**BLUE RIVER PLANNING AND ZONING COMMISSION MEETING MONTH**

**Tuesday, April 1, 2025**

TO: Michelle Eddy, CMC/CPM - Town Manager/Clerk  
FROM: Kyle Parag, Plan Reviewer - CAA  
DATE: March 27<sup>th</sup>, 2025  
RE: Planning/Zoning/Architectural Guidelines review – 5940 HWY 9

TO: Michelle Eddy, CMC/CPM - Town Manager/Clerk  
FROM: Kyle Parag, Plan Reviewer - CAA  
DATE: March 27<sup>th</sup>, 2025  
RE: Planning/Zoning/Architectural Guidelines review – 0132 Mountain View Dr

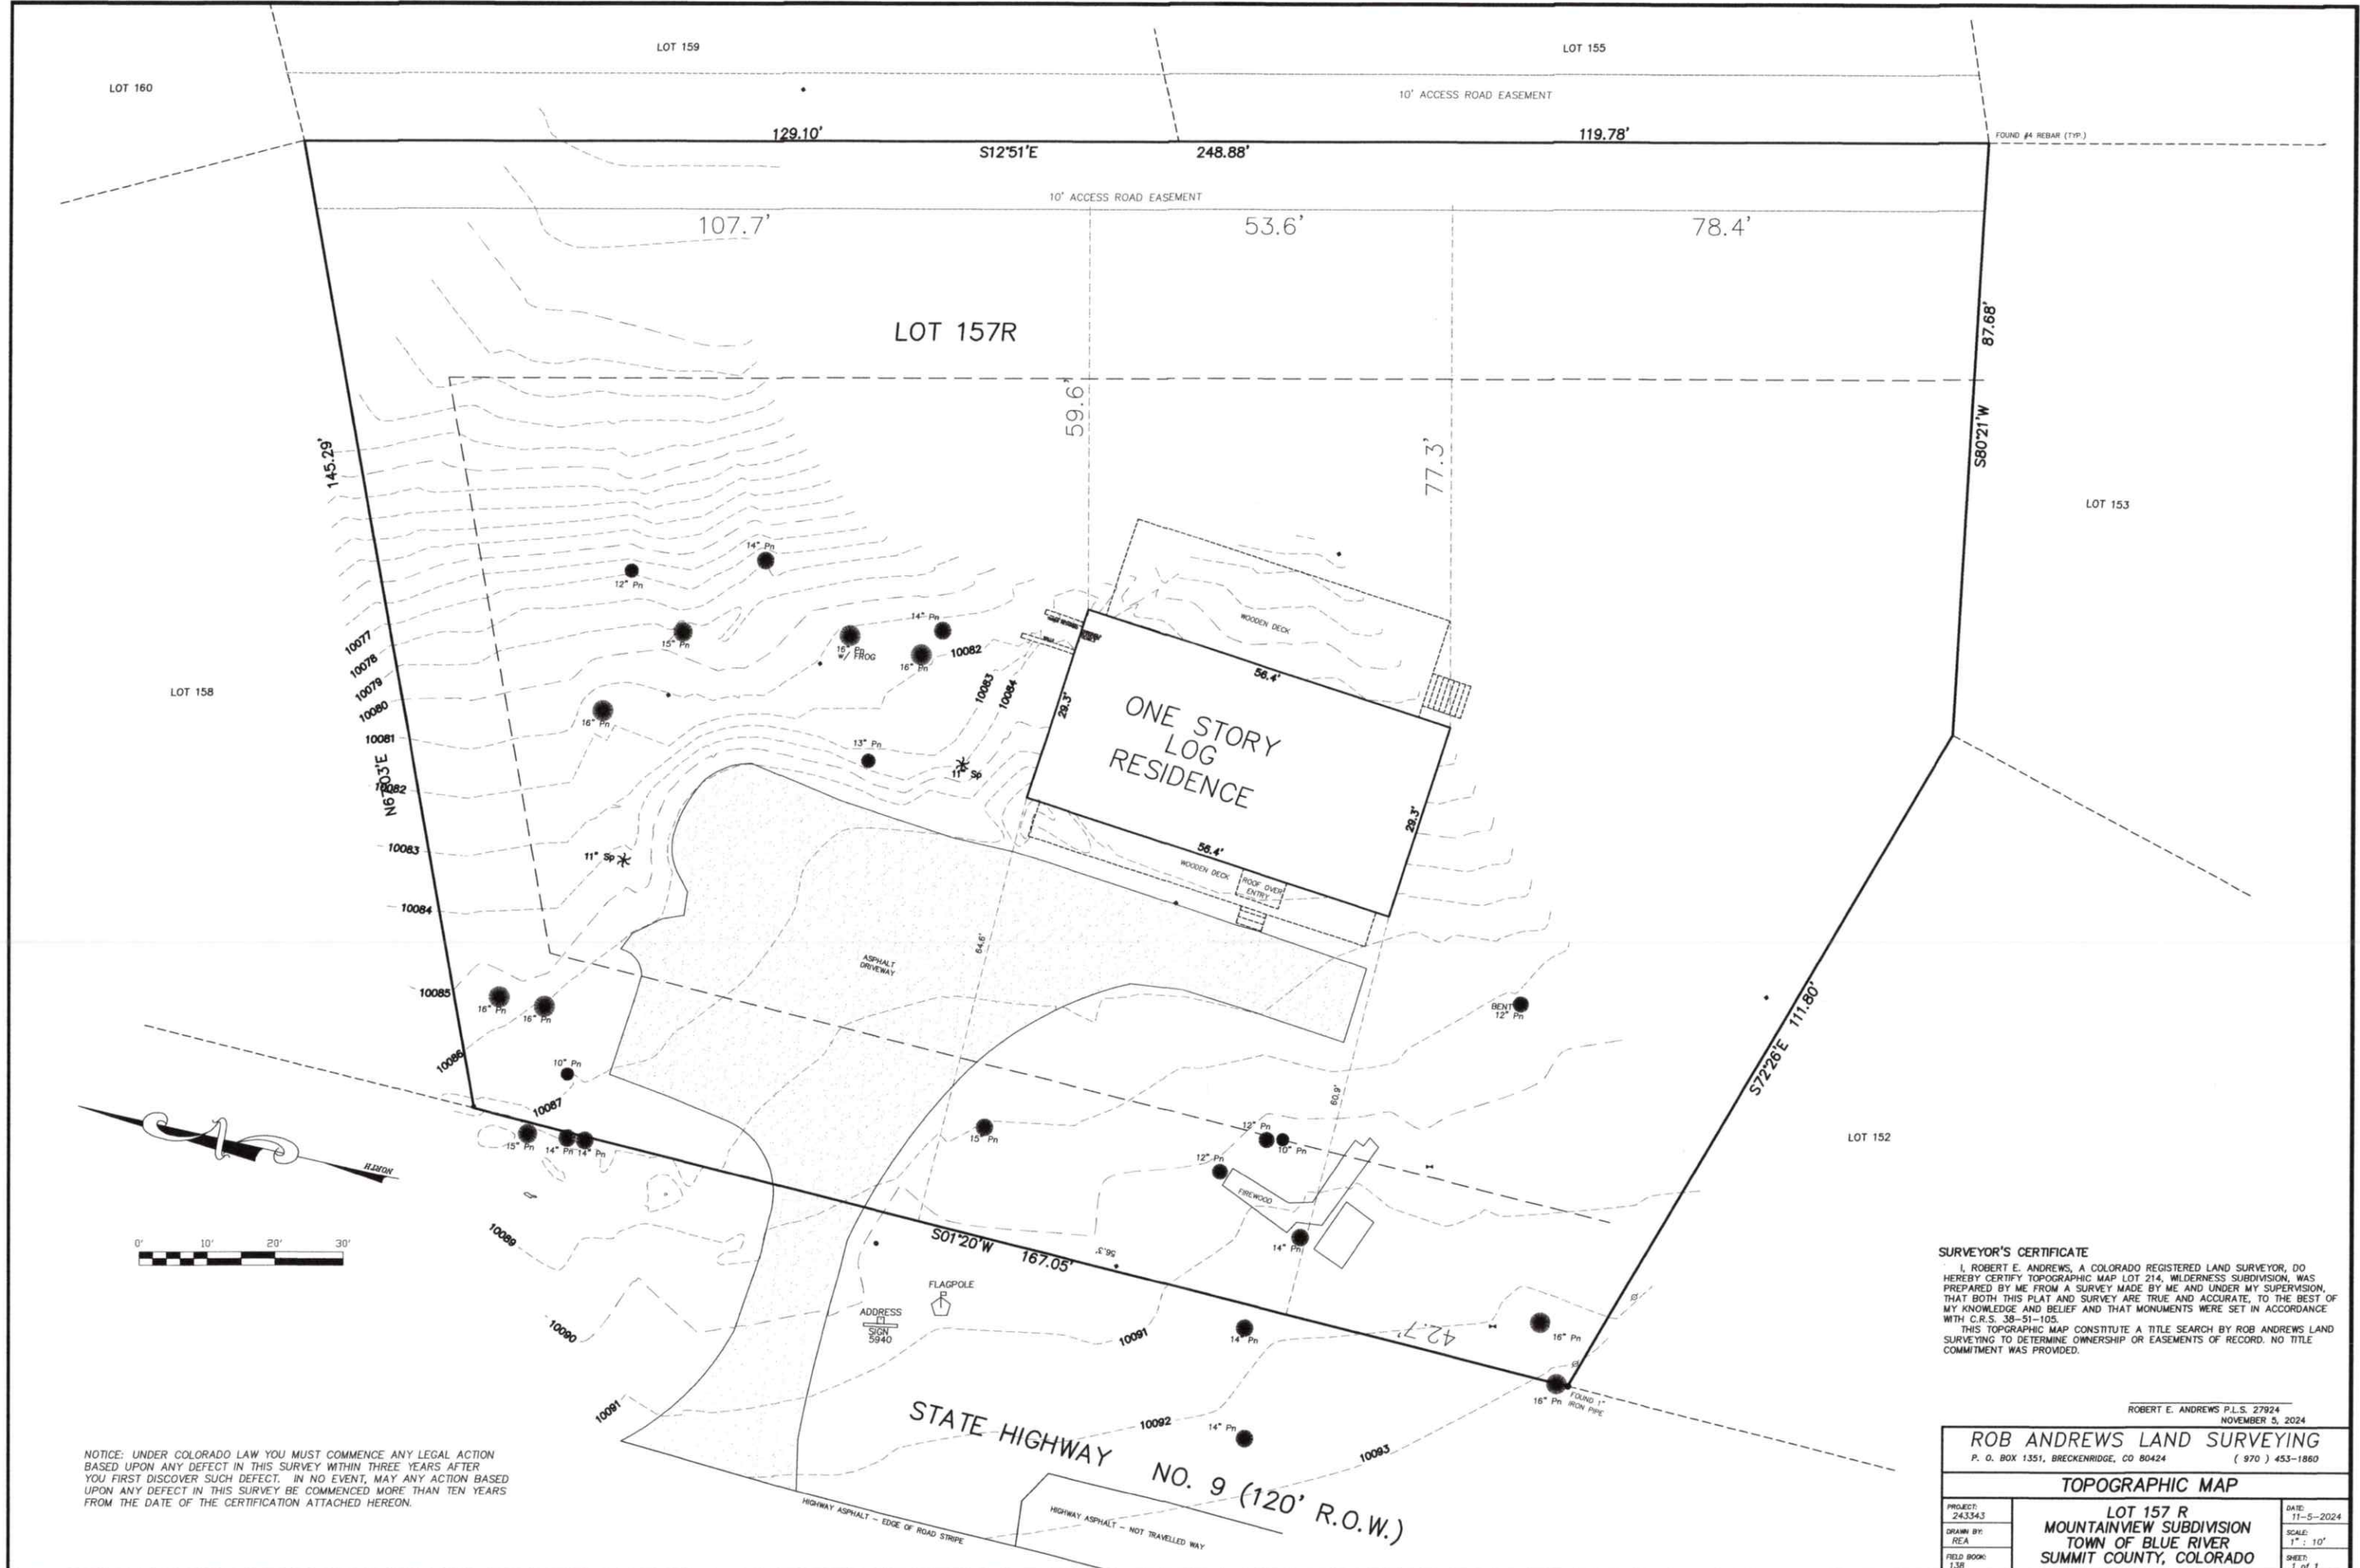
STANDARD	NOTES/REMARKS	SUBSTANTIAL COMPLIANCE
<b>DEVELOPMENT STANDARD</b>		
Article 3: Easements	Easements are indicated	Y
Article 4: Buildable Area/setbacks	Front setback is indicated correctly	Y
<b>Article 5 Building Design Standards</b>		
Article 5-20 Building Height	Height is indicated at 26.5'. Section 16B-7-30 (d) requires detached garages to have a height less than the principal structure.	PC
Article 5-60 Foundation	Foundation is not clearly indicated, but appears to be exposed concrete.	N
Article 5-70 Roofs	Main roof design is a gable roof, with a pitch of 9:12	Y
Article 5-80 Garages	Garage door fits the style of the home.	Y
Article 5-90 Window and doors	Windows are sized to complement the home	Y

Article 5-100 Balconies and railings	N/A	Y
Article 5-110 Chimney and Roof Penetrations	N/A	Y
<b>Article 6 Building Materials and Colors</b>		
Article 6-20 Materials	Siding is horizontal siding meant to imitate the existing log cabin. Unclear if proposed design meets the requirements of (e) for consistency with building materials.	PC
Article 6-30 Colors	Colors are provided and show general compliance.	Y
<b>Article 7 Accessory Improvements</b>		
Article 7-(20-40, 110) Berms, Garages, sheds and Gazebos	N/A	Y
Article 7-50 Driveways	Driveway modification will be minimal.	Y
Article 7-60 Parking Areas	N/A	Y
Article 7-100 Decks	N/A	Y
Article 7-120 Hot Tubs	N/A	Y
Article 7-140 Fences	N/A	Y
Article 7-150 Retaining walls	Retaining wall may be required on rear of garage, but not indicated at this time. Finished slopes cannot exceed 2:1	Y
<b>Article 8 Signs</b>

Article 8 Signs	None indicated	Y
<b>Article 9 Lighting</b>		
Article 9 Lighting	Downcast lights are NOT shown graphically but textually indicated.	PC
<b>Article 13 Environmental Regulations</b>		
Article 13-20 Wetlands	None indicated	Y
